HISTORIC AND DESIGN REVIEW COMMISSION

HDRC CASE NO: 2018-378
ADDRESS: 213 E TRAVIS ST
711 NAVARRO ST
LEGAL DESCRIPTION: NCB 408 BLK 15 LOT 18 EXC W6 FT OF N51.5 FT OF S161.5 FT & 19
ZONING: D, RIO-3
CITY COUNCIL DIST.: 1
APPLICANT: Peter French/Graystreet
OWNER: Graystreet Travis Garage, LLC
TYPE OF WORK: Construction of an addition to the existing parking structure, site work, exterior modifications
APPLICATION RECEIVED: July 25, 2018
60-DAY REVIEW: September 23, 2018

Project Name
**Travis Park Plaza Parking
Garage Addition**
Project Number
25.1451.000

Description
SITE PLAN

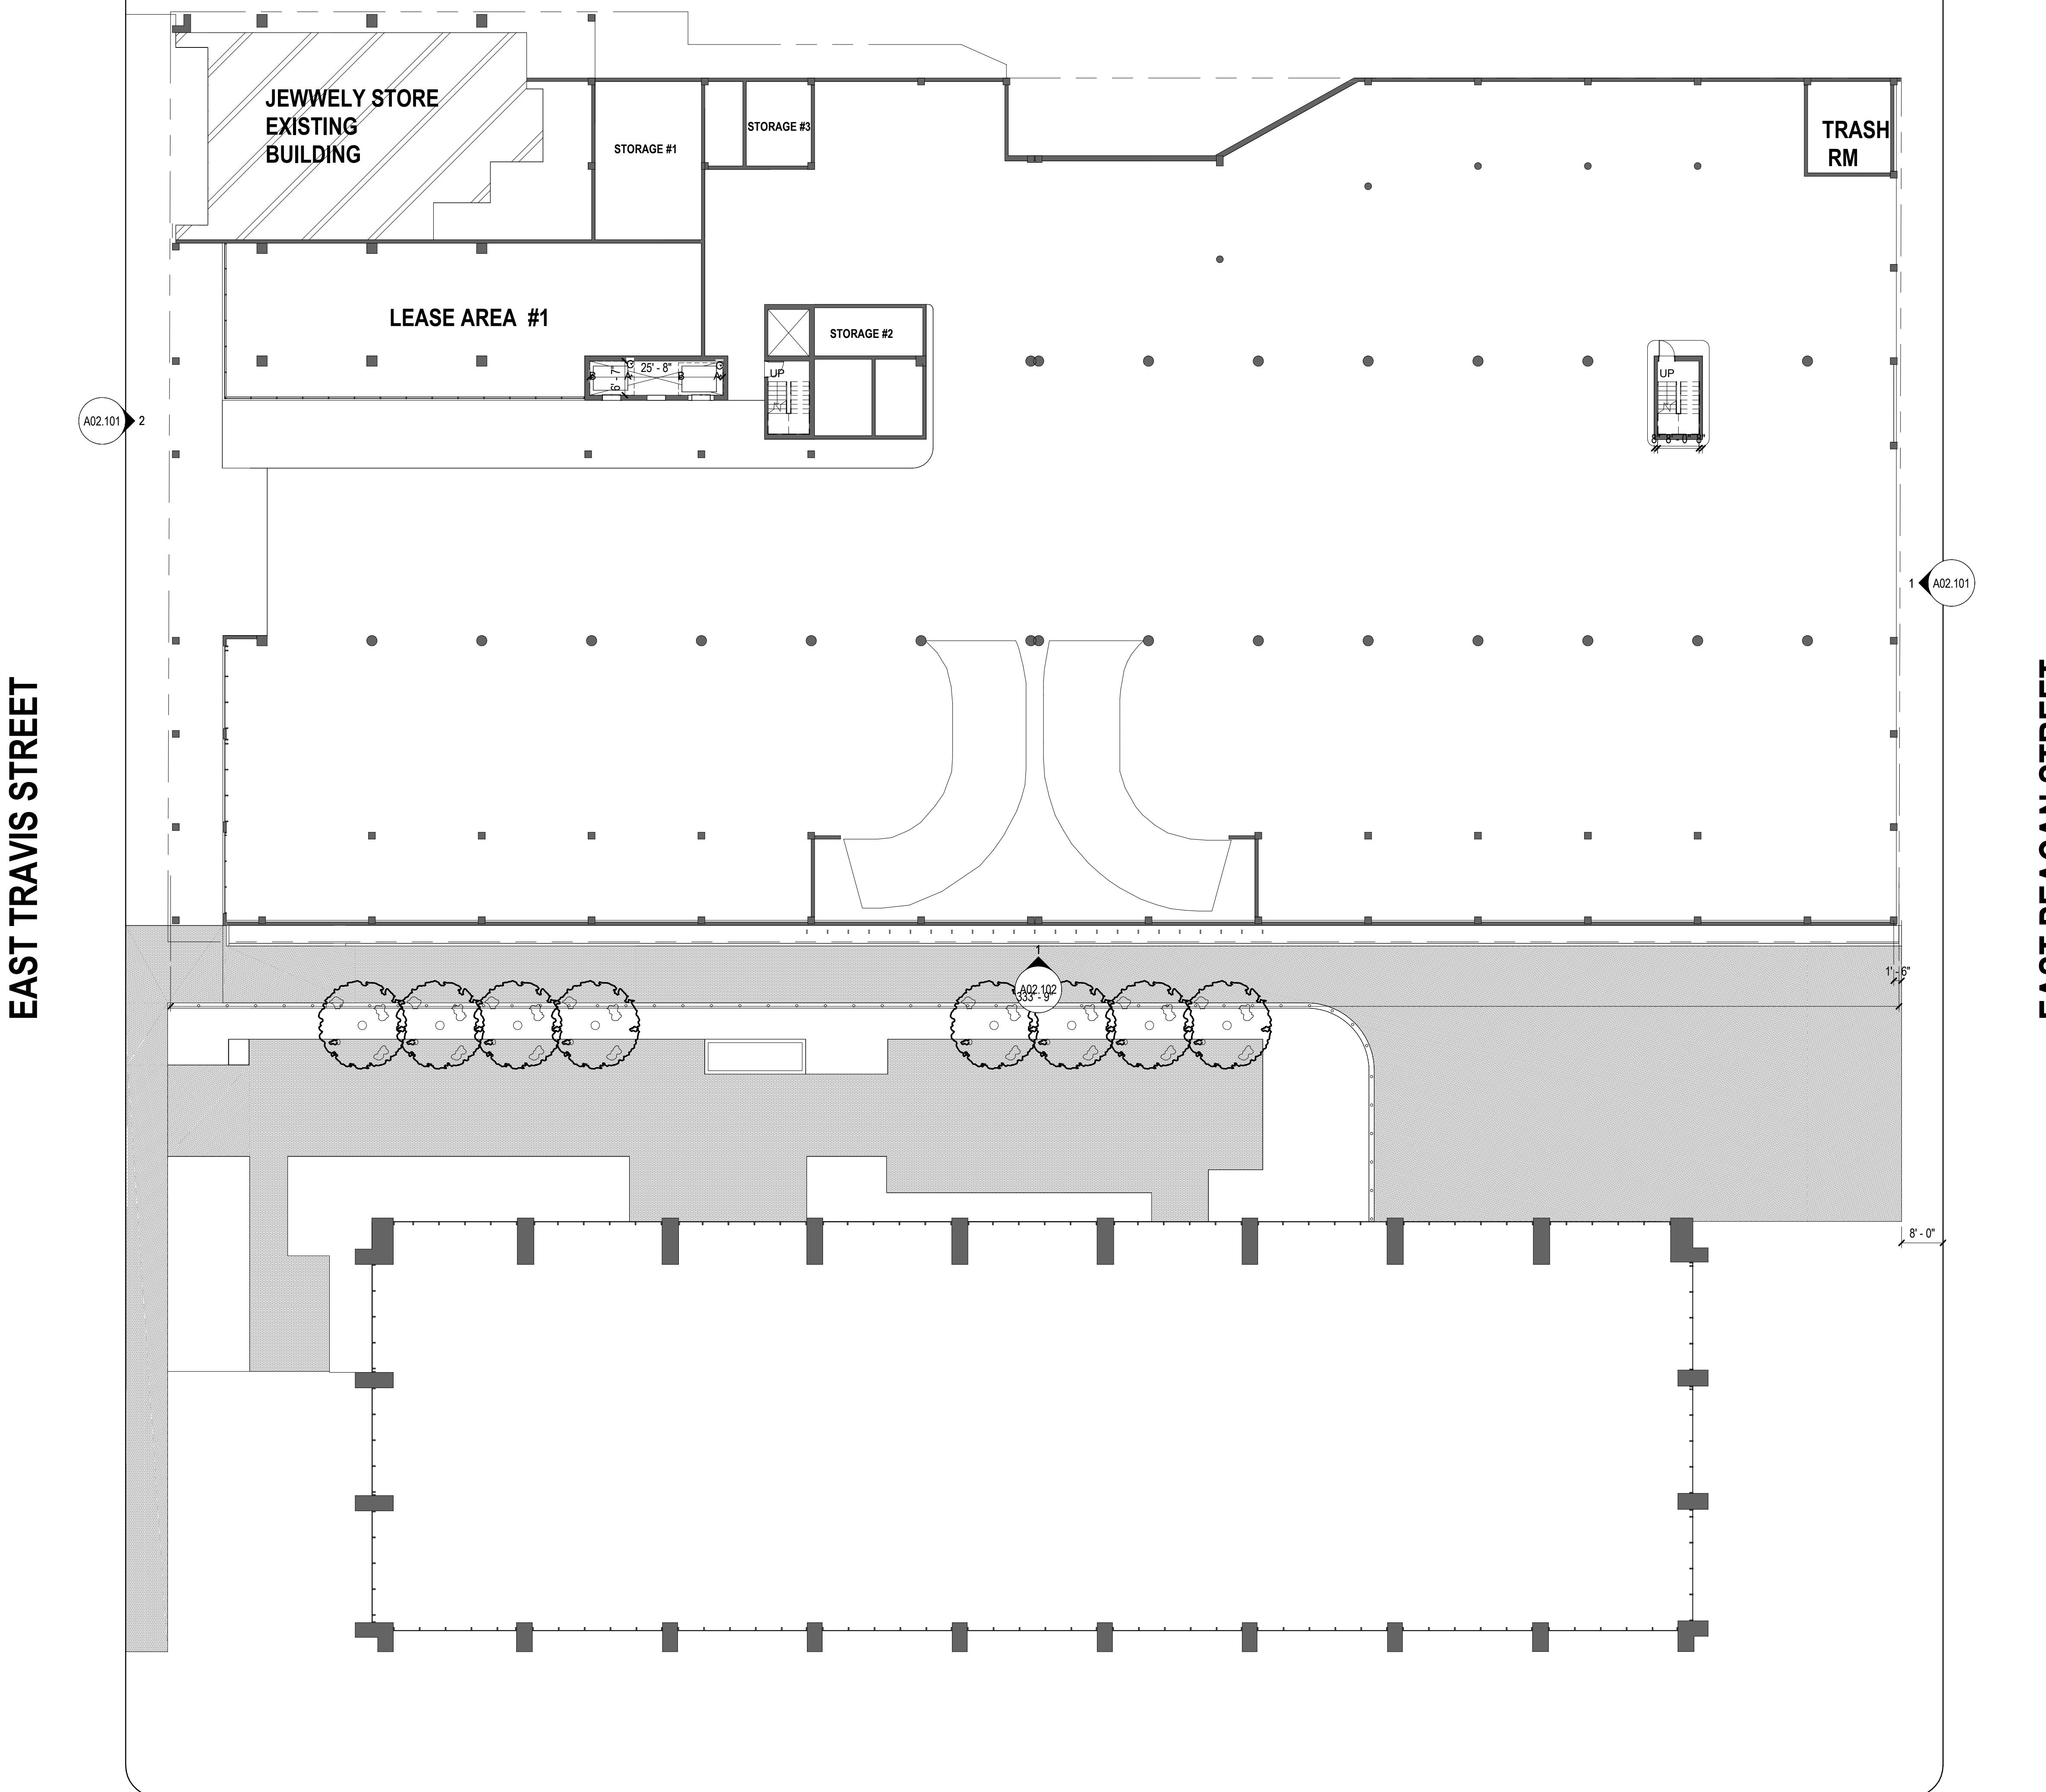
- f. SITE & LANDSCAPING MODIFICATIONS – The applicant has proposed landscaping modifications that include the installation of new planting beds into the existing plaza areas located along Navarro, E Travis and E Pecan. Staff finds the proposed landscaping modifications appropriate; however, a detailed landscaping plan should be submitted when returning to the commission for final approval.

BUILDING ELEVATIONS

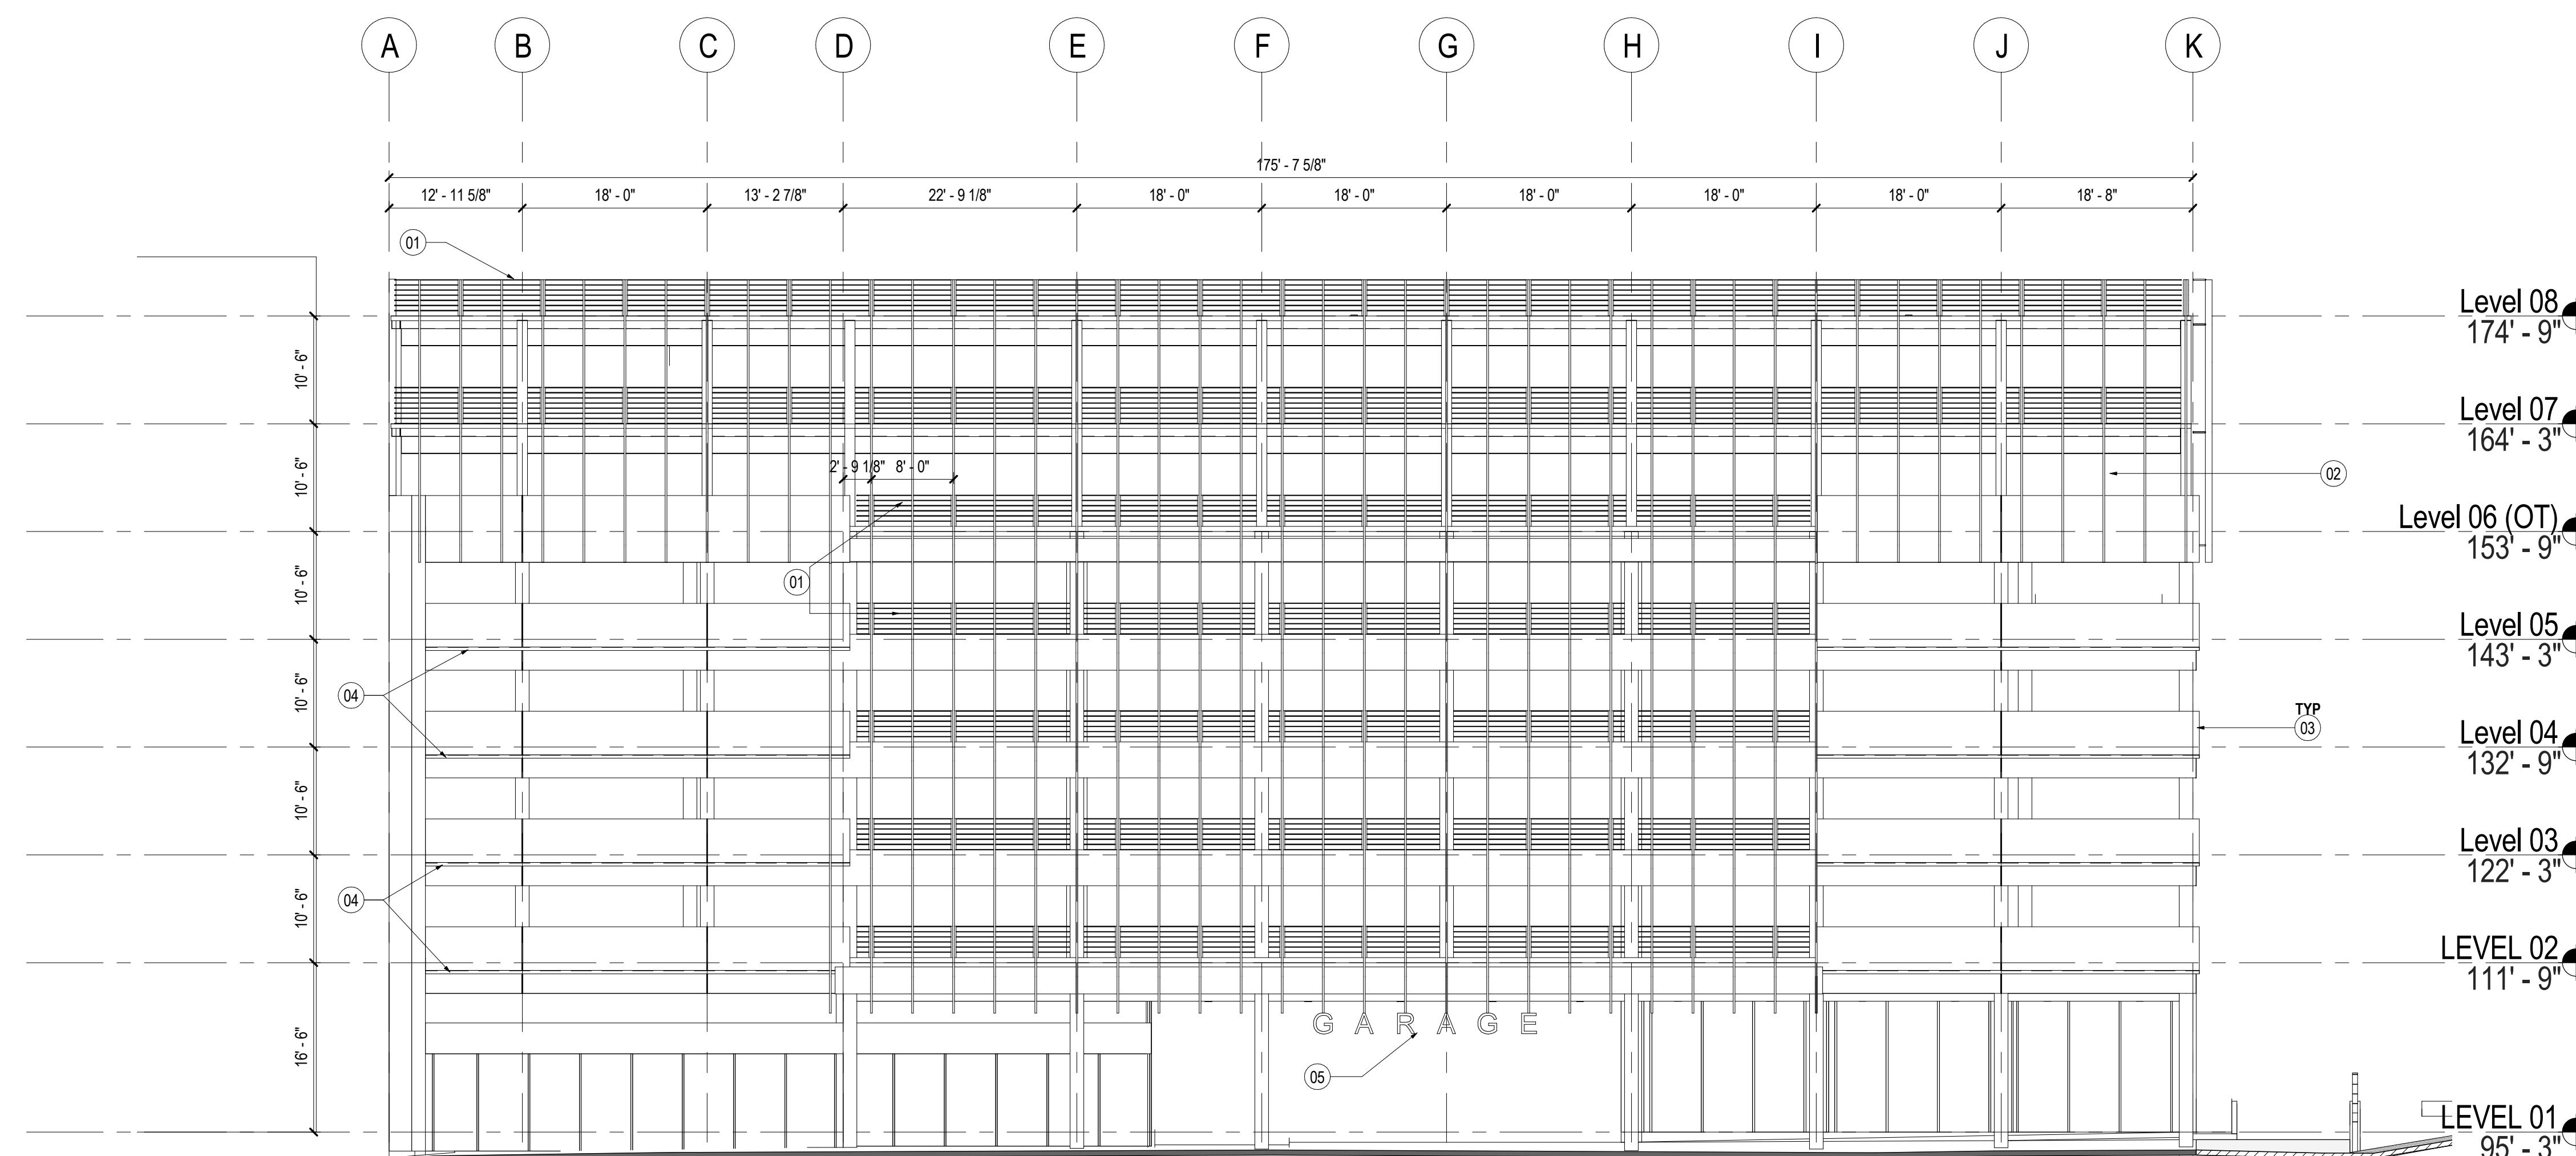
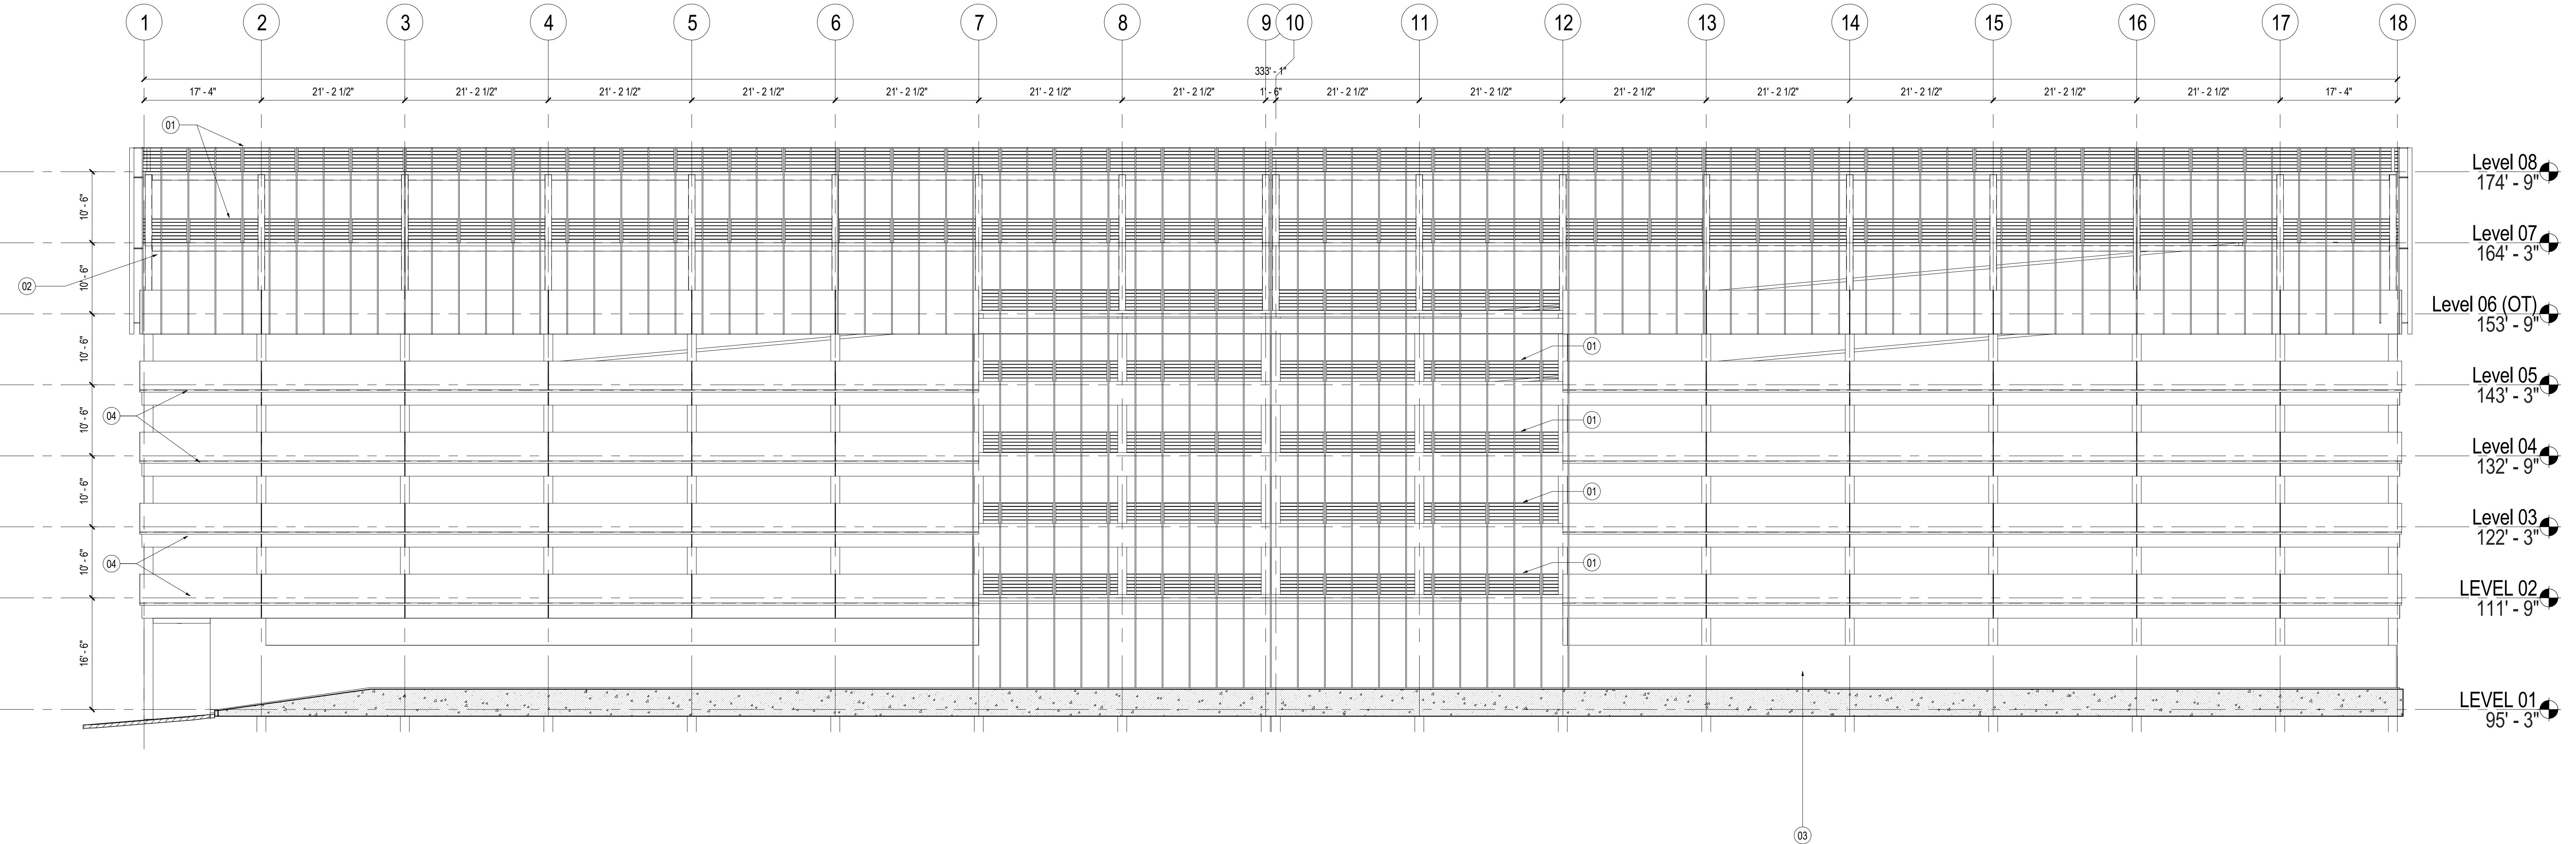
- c. EXTERIOR MODIFICATIONS – The applicant has noted exterior modifications to the existing garage structure which include the installation of a fin screen, the installation of a new storefront system for the existing ground level retail spaces, the installation of vegetative screening wall at the ground level on the east elevation and painting. Generally the proposed modifications are consistent with the UDC. Staff finds that the applicant should specify the plant species that will be installed on the vegetation screen and provide a detail of the proposed new storefront system and fin screen.

- i. That the applicant submit detailed drawings and materials specifications for the proposed storefront system and fin screen.
- ii. That the applicant submit detailed drawings and materials specifications for the proposed canopies.
- iii. That the applicant submit a detailed landscaping plan that includes the proposed vegetation screen.
